LARAMIE COUNTY PLANNING & DEVELOPMENT DEPARTMENT

TITLE: PUBLIC HEARING regarding an approval of the Subdivision Permit and Plat for Pita Ranch, 2nd Filing, situated in a portion of the N ½ SE ¼ of Section 34, Township 14 North, Range 63 West, and a portion of Tract 1, PITA RANCH, Laramie County, WY.

AGENCY REVIEW COMMENTS #1

RESPONSES TO AGENCY REVIEW COMMENTS #1

PITA RANCH 2ND FILING

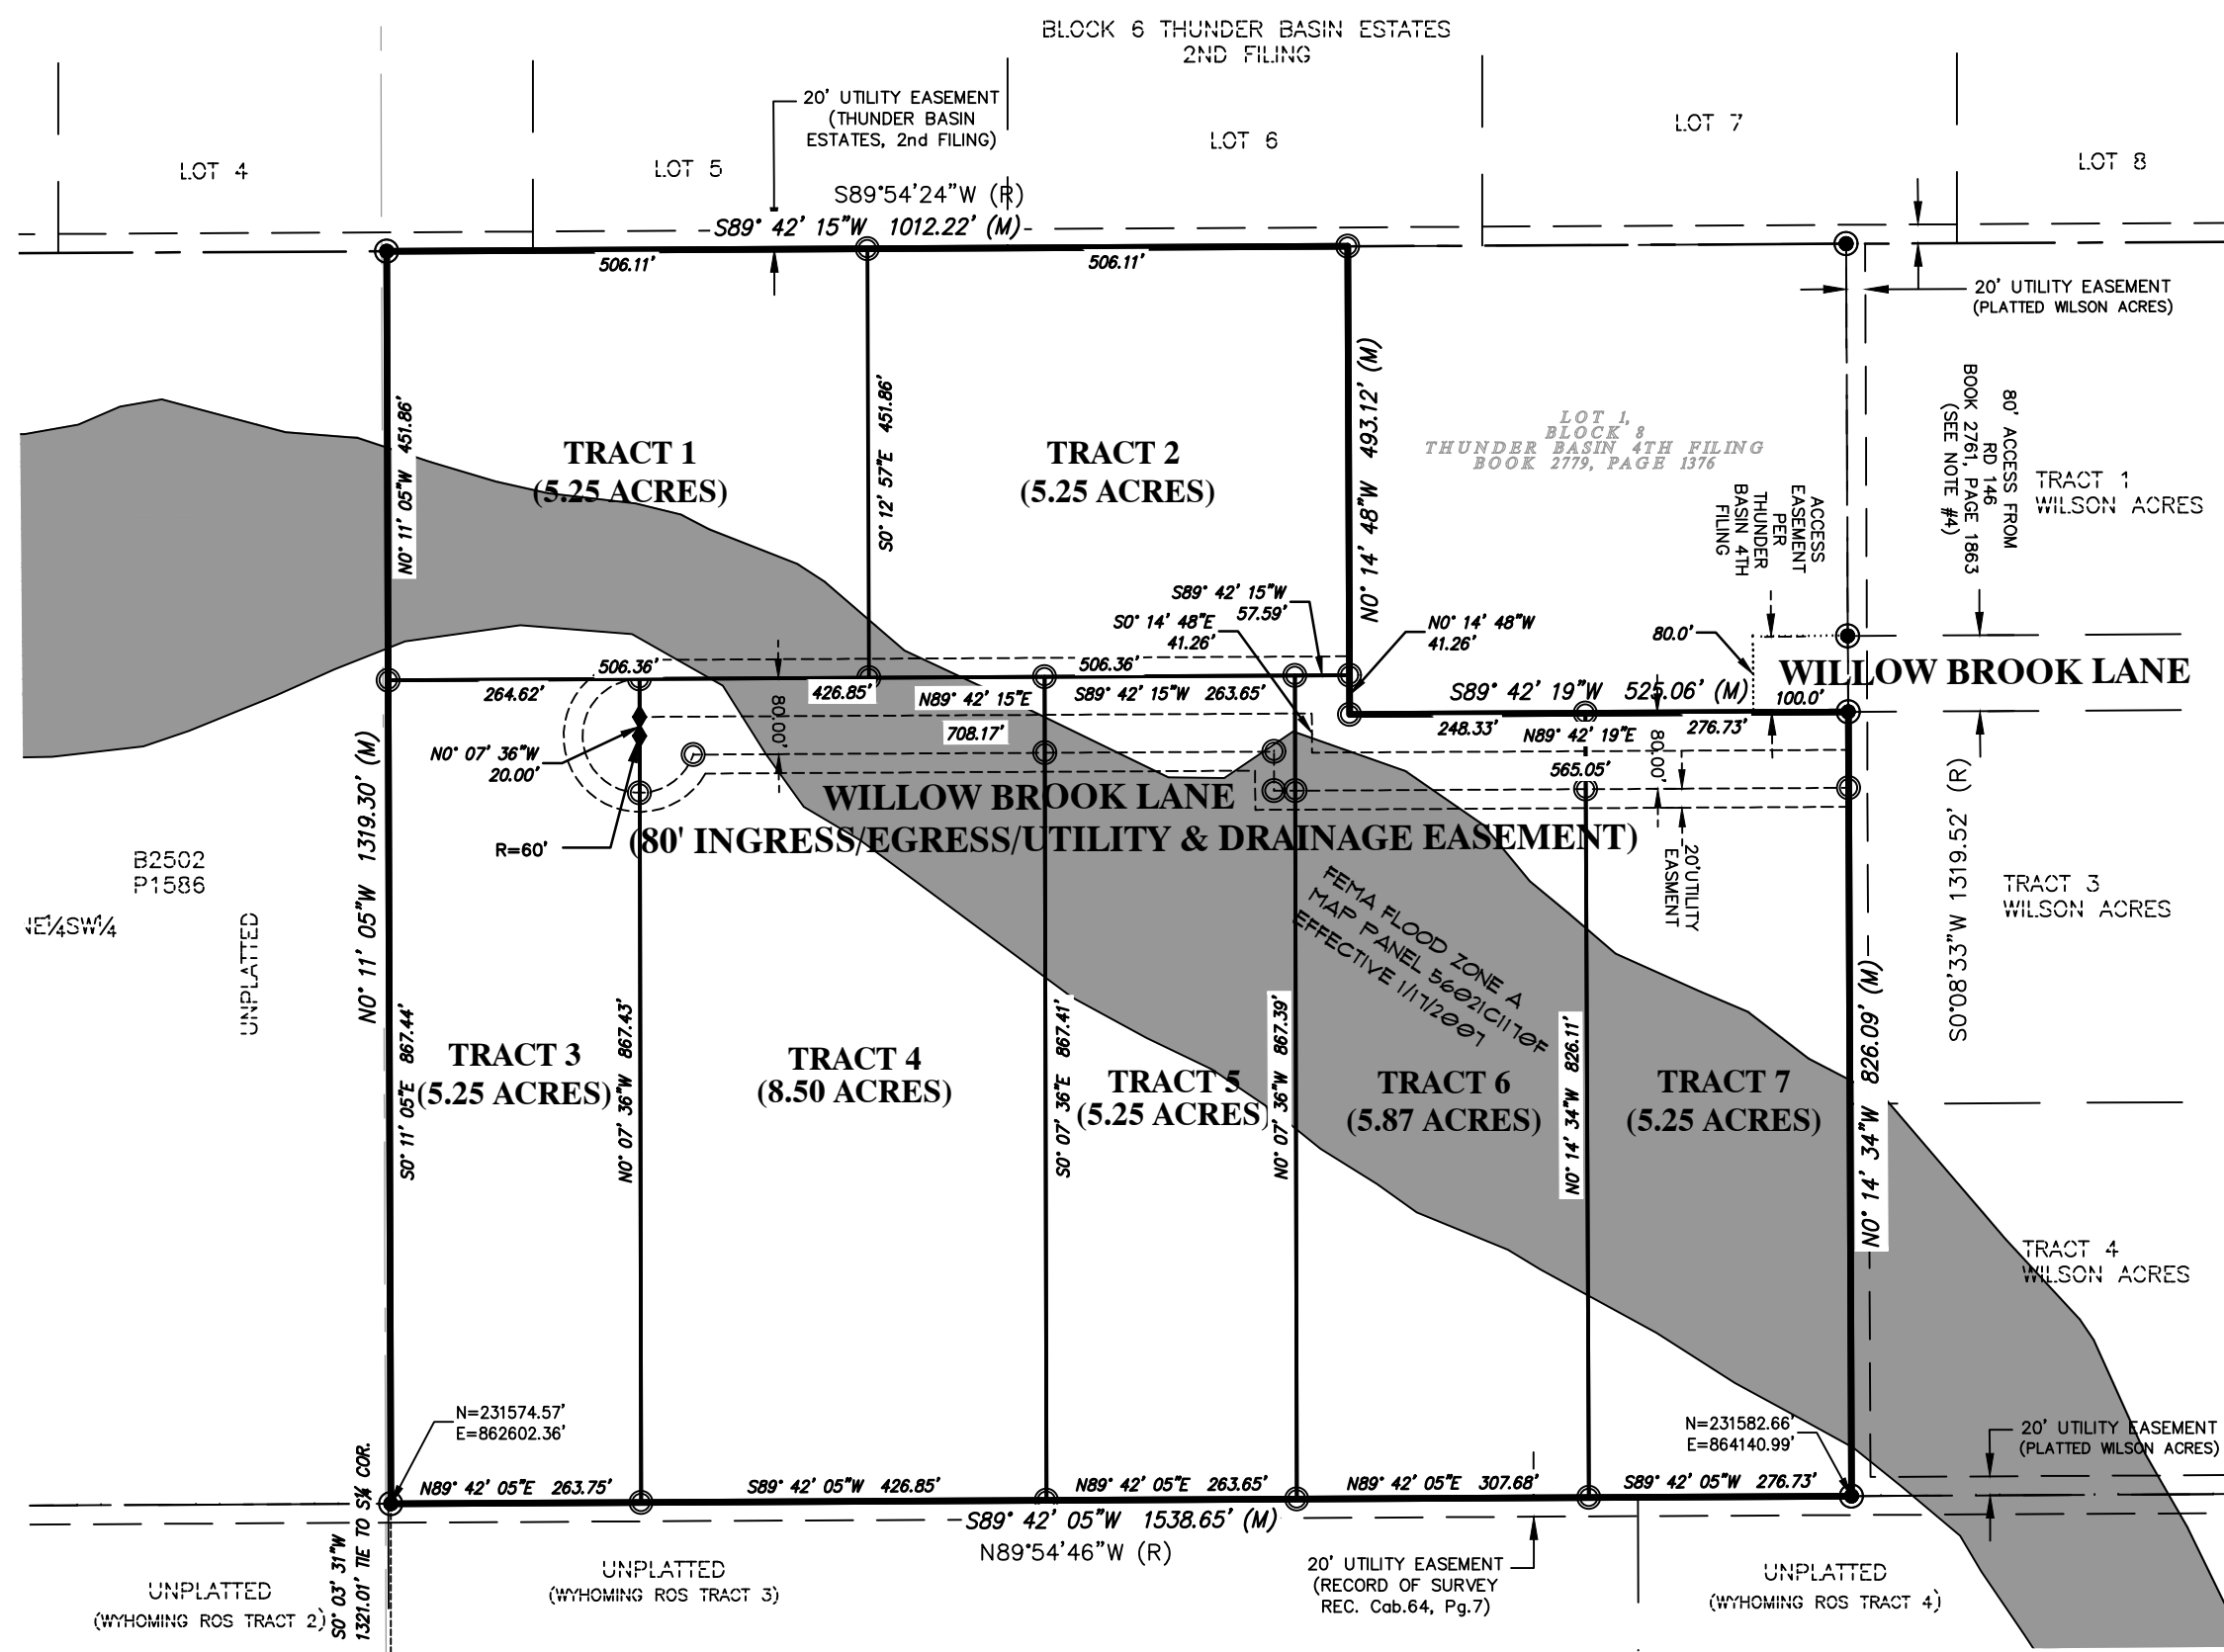
1. It appears the area defined in the Legal Descriptions included in the DEDICATION, which are intended to describe the property to be included in this subdivision, also includes Lot 1, Block 8 of THUNDER BASIN ESTATES 4TH FILING. The first description describes a rectangular parcel which is approximately 2860 feet by approximately 1320 feet. The two exceptions describe the WNESW and ENESW of Section 34, the part of the first description falling west of this subdivision.

2. There are no Wyoming State Plane field observation coordinates shown on the plat.
3. There is a line segment near the southwest corner of Lot 1, Block 8 of THUNDER BASIN ESTATES 4TH FILING labeled as 41.62 feet. There is another 41.26 line segment label falling more or less in the middle of WILLOW BROOK LANE, just southwest of the first mentioned 41.26. The second 41.26 is not clearly shown as attached to any specific line segment.

4. The only curve data shown at the west end of WILLOW BROOK LANE is the radius. It is necessary to identify at least one more piece of curve data to adequately define the curves, the central angle, the arc length, or the chord bearing and distance. The Laramie County Subdivision Regulations require that all be shown.

5. All of the easement boundaries and street boundaries are identified with dashed lines. The center line of WILLOW BROOK LANE is also identified with the same type of dashed line. It would be helpful and make the plat a little easier to read if the center line would be a more standard center line type line.

6. It might make the right-of-way of WILLOW BROOK LANE a little more easily locatable, clearly defined and easier to sort out the dashed lines, if one were to add a couple of 80 easement dimension lines.

7. The VICINITY MAP would be more congruent with the Title Block requirements and helpful to all users of the subdivision plat if one would add the Township and Range data to the VICINITY MAP.

Many of these lots are affected by the Floodplain. Specifically lots 6 and 7 look to have about 50% of each lot in the floodplain.

Property falls within the AMEC memo and will have to be a minimum of 5.25 acres. Small waste water requires that the lots hit a minimum of 5 acres. The lots may all be compliant, however I cannot read what the size of lot 5 is to make this determination.

We need more information on the ingress/egress onto the properties from Road 146. How are the property owners going to get from Road 146 to the properties? Is this through Wilson Acres Tract 2? Is there an easement/access agreement for the future property owners to continue to use this access? Also, it looks like there is a sharp turn toward the south when the access hits the west end of Wilson Acres Tract 2. The access will have to use up neighbors' property to create the access as drawn. How is this going to be addressed?

1. ACKNOWLEDGED 2. ACKNOWLEDGED 3. ACKNOWLEDGED 4. CORRECTED

- Lot 1, Block 8 is one of the exceptions. dedication updated
- 2. ADDED
- 3. CL OF ROAD LABEL MOVED
- 4. ROAD IS EASEMENT - NOT DEDICATED-DIMENSIONS OF LOT LINES GO TO THE RADIUS POINT - NOT AROUND THE EASEMENT CURVE.
- 5. EVERYTHING IS LABELED
- 6. ADDED
- 7. ADDED

ACCESS IS LABELED WITH BOOK AND PAGE.
AL ACCESS IS IN LEGAL EASEMENTS.
